**Bulletin ID:** UBCO-CS-00018  
**Date of Issue:** 02/08/2024  
**Bulletin type:** Service Bulletin  
**Audience:** UBCO DUTY Service Agents & Authorised Repairers

## DUTY – Post-production Rework

**Title:** Addition of P-clip for horn cable

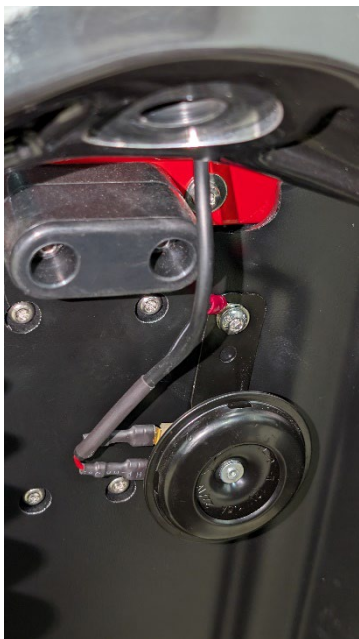
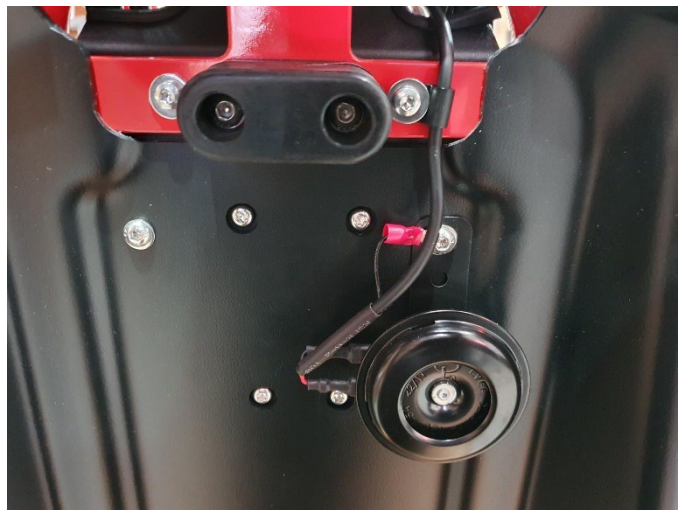
**Issue:** If the horn wire isn't retained it can get crushed between the steering stop and the triple clamp.

**Action:** P-Clip to be installed on the wire.

**Title:** lube side/centre stands and foot brake

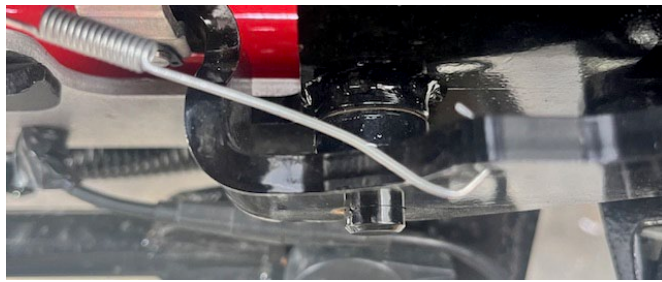
**Issue:** During production, no lubrication was applied to the side/centre stands and the foot brake lever.

**Action:** Lube is to be applied to the side and centre stands and the foot brake lever. This can be carried out by moving the stand to one side and spraying in the pivot point, complete the same for the opposite side.

Use circlip pliers to remove the foot brake lever circlip to expose the shaft, spray lube and install the circlip.

**Title:** Long bolt supplied with seats incorrect

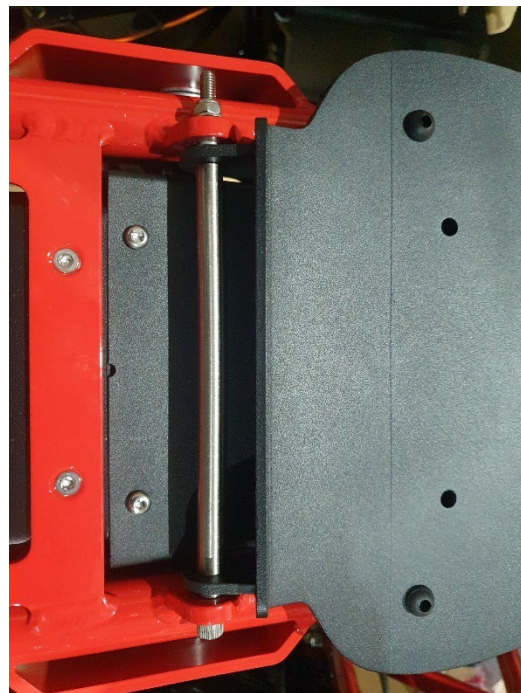
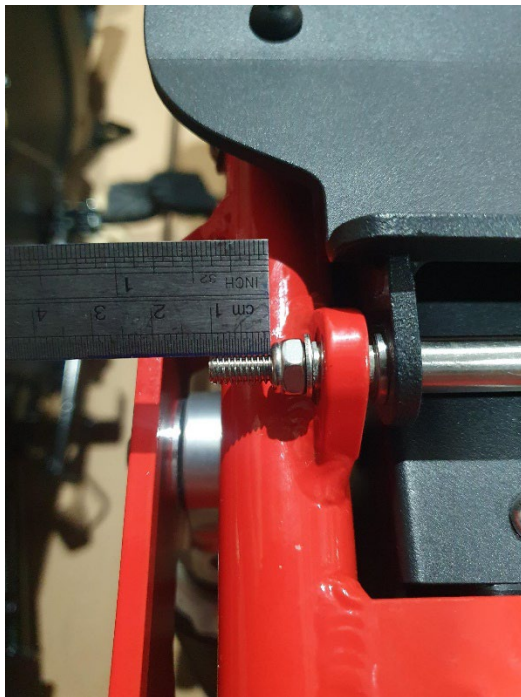
**Issue:** Bolt supplied for with seat to long.

**Action:** Do not use the supplied single bolt, instead use bolts already installed on the seat pan. Return incorrect parts to UBCO AU.

**Title:** Check all brake banjo fittings are firm on the CBS unit behind the front console

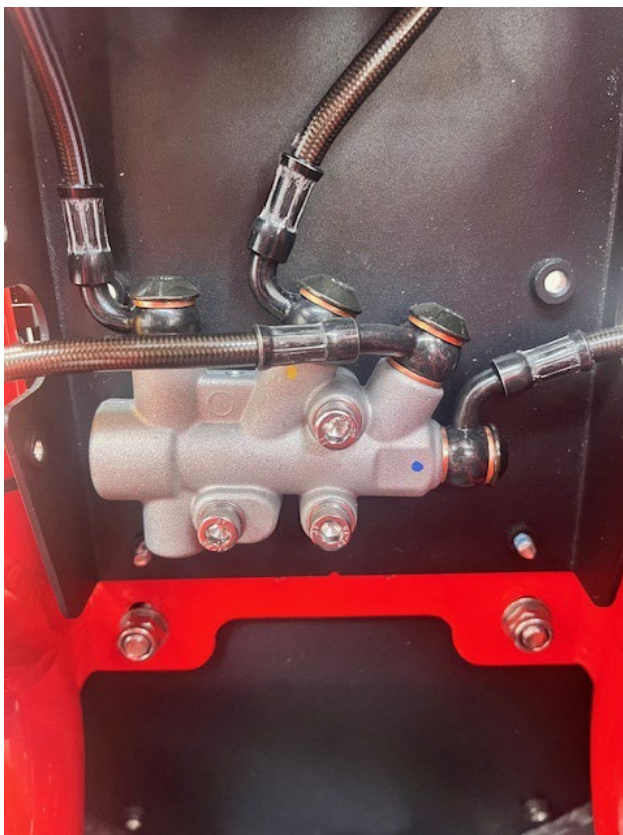
**Issue:** x2 banjo fittings were found to be loose during QA check of bikes when landed in AU. This resulted in some of the brake fluid being lost and poor brake handle pressure.

**Action:** Inspect banjo fittings on CBS unit while front console is removed to ensure tight and nil leaks. Tighten as necessary to 25NM. Carry out brake system bleed if necessary to regain handle pressure.
